PROPOSED TRAFFIC SIGNALS AT COMMON LANE/NEW ACCESS ROAD, KENILWORTH

Subject: PROPOSED TRAFFIC SIGNALS AT COMMON LANE/NEW ACCESS ROAD, KENILWORTH

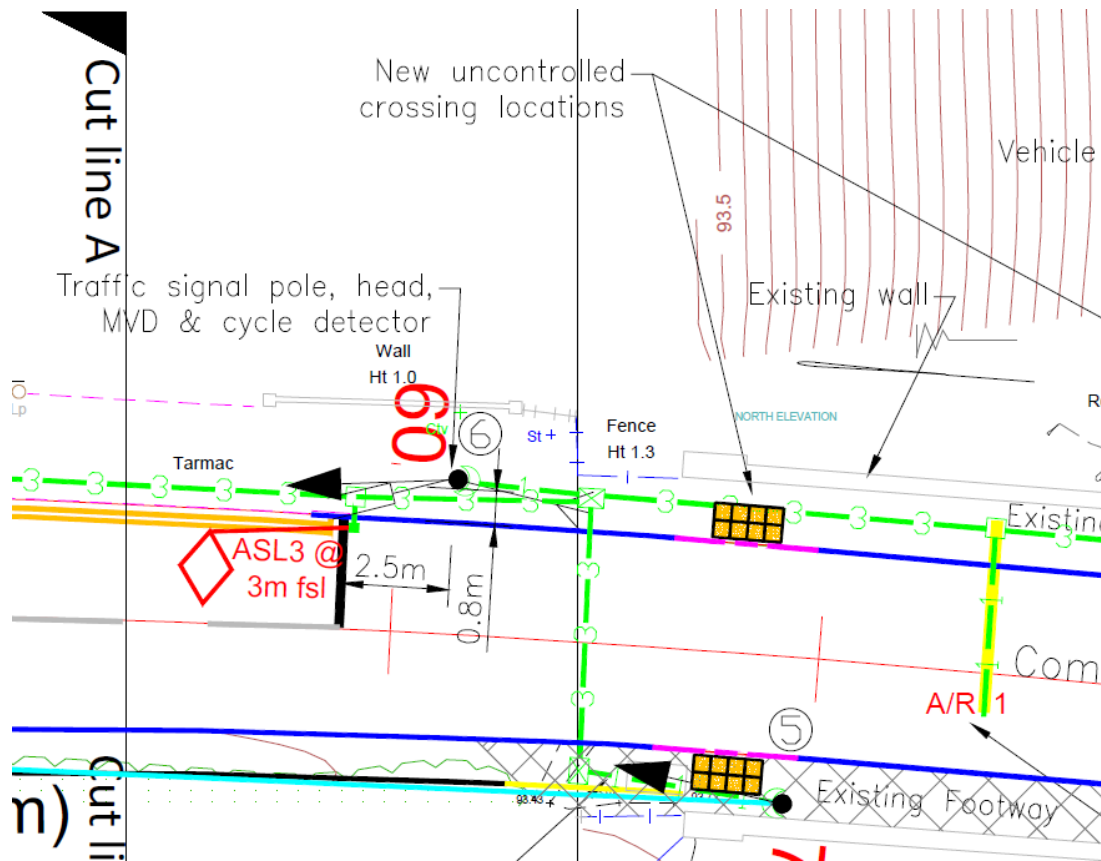
Whilst I understand your suggestion of moving the stopline further towards the site access, the width of the road across the bridge is such that it is not possible to widen the footway enough to install a traffic signal pole and keep enough room for pedestrians to pass, and have a lane for traffic queued at the stopline and still have enough road width for vehicles to pass the queuing traffic. I must make you aware that in order to move the traffic signal pole away from [REDACTED] as requested, it has meant that the pole and, as a direct result, the stop line have been moved slightly closer to [REDACTED] driveway as you can see on this extract. This should not conflict with the location of the Virgin Media cable, but we are aware that other utility apparatus will need to be diverted as part of the works. (The green dashed lines are the ducts needed for the traffic signal cables.)

(2) With regard to traffic light location no. 6 , it is difficult to understand exactly where this is proposed to be located but, as discussed on site, you should note that I have a pedestrian access to my property in the immediate vicinity which you would be potentially blocking. Also there is a Severn Trent water meter & Virgin fibre optic cable in the immediate location.

(3) Tradesmen working at our houses (plus delivery vehicles etc) often cannot get onto our driveways so may need to park outside in the road which they do at the moment. Obviously this would cause major problems if the traffic lights were to be located at 5/6 as shown on the plan but to a much lesser extent if located as suggested in (1).

- (4) Safety : There has never been a notable accident in living memory in the area of the bridge; people approach with caution - the present system works reasonably well. With your new one-way system, many will race through the bridge thinking they are safe to do so. When reversing into Common Lane to go towards Coventry Rd from nos. [REDACTED] in particular, I believe we would feel threatened by vehicles coming up the hill through the bridge at speed around the semi-blind corner. Solution - an additional appropriate warning sign at the lights at location 4 ;
